To:  
Director - Energy Assessments  
Planning and Assessment  
Department of Planning, Industry and Environment  
Locked Bag 5022  
Parramatta. NSW 2124

26 January 2021

**I am objecting to the HILLS OF GOLD WIND FARM APPLICATION NO. SSD 9679**

### Photomontage 13

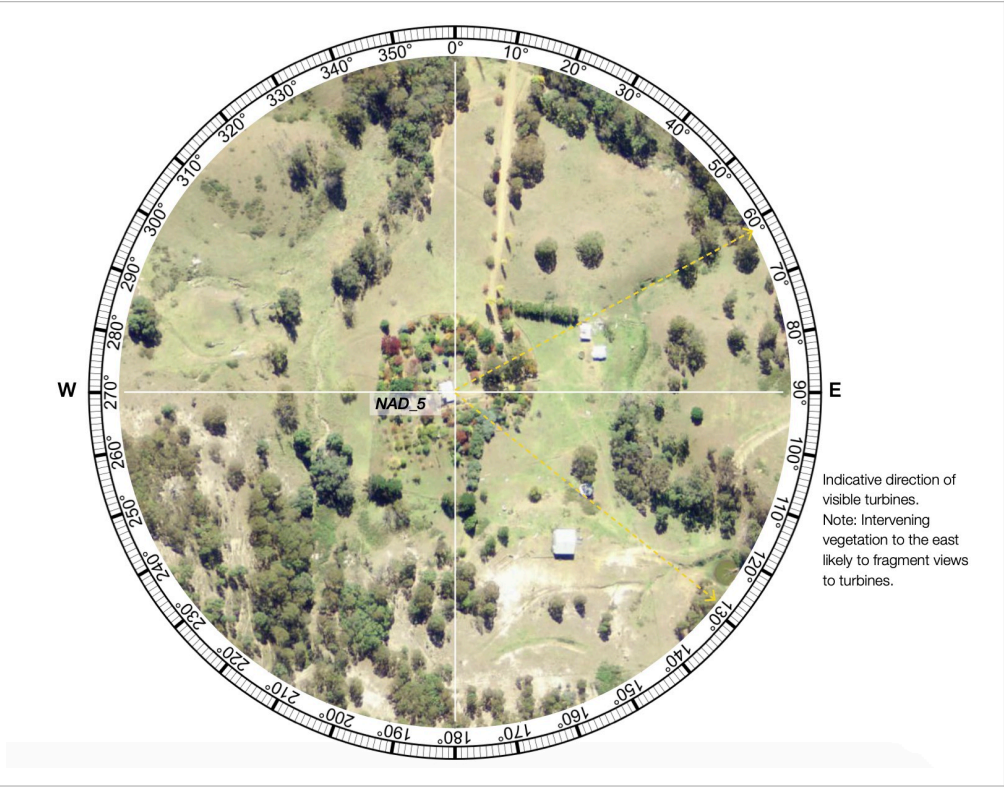
This image shows amount of plantings already around our house. How is proposed “screen planting” going to make a difference to block out turbines???

The tree on the right side of image is 30 YEARS OLD!! And it's still not blocking out turbine. If they plant more, trees will take long time to grow. Wind farm will be gone by then. The tree on the left side is now dead. It died in the drought! Trees on the ridge covering bottom parts of turbines belong to wind farm host and we have no confidence in their future.

We can't plant any more plants closer to house because of fire risk!!

It will block sun to the bedroom window!!
